Fencing Project 2021- Mason County PUD 1

Job Site: 21971 N. Highway 101, Shelton, Washington 98584

Questions from Pre- Bid Walkthrough

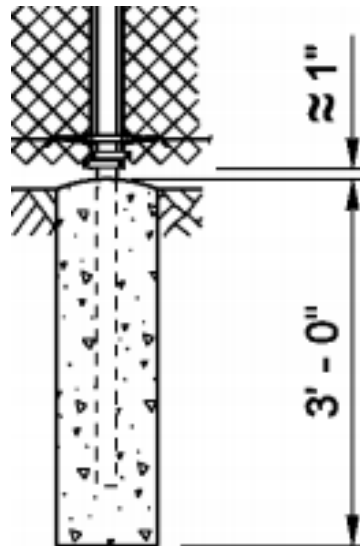
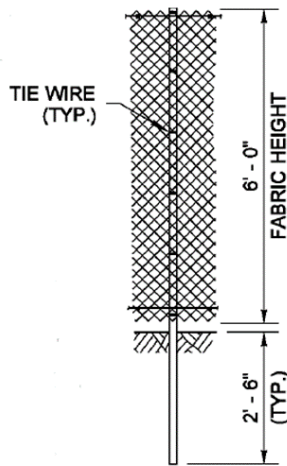
1. What is the standard for the fencing?

a. The PUD asks that State DOT standards are used in the fencing and that the fencing matches the fencing that is currently in place. The fence itself should be 6 feet tall, with 1 foot of barbwire (3 strands) on top the 6-foot fence. The poles used are 3 inches in diameter. The poles should be placed a minimum of 30 inches below ground, please use footing diagram below for reference. All concrete post bases should be 10" (in) minimum diameter.
